Job Name:	1 Henfaes Road, Tonna, Neath Port Talbot, SA11 3DX	Job N ^o :	IMA-24-077
Date:	18 th November 2025	Client:	Emily Byrne

NEATH PORT TALBOT COUNTY BOROUGH COUNCIL
ENGINEERING & TRANSPORT - ACTIVE TRAVEL OBSERVATIONS

Planning Application No: P2024/0818

IMA Designer's Response to Active Travel Observations

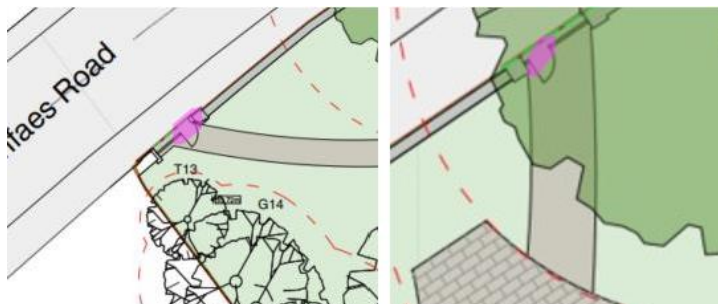
- 4.2 The path width highlighted in pink appears narrow. Can the widths be confirmed

The Site Layout has been reviewed. The footway across the site is 2m wide and the strip serving plot 4 and 5 is 1.1m wide. Please refer to both drawing IMA-24-077_010C General Arrangement and Architect's Site Plan 1566 026 P2.
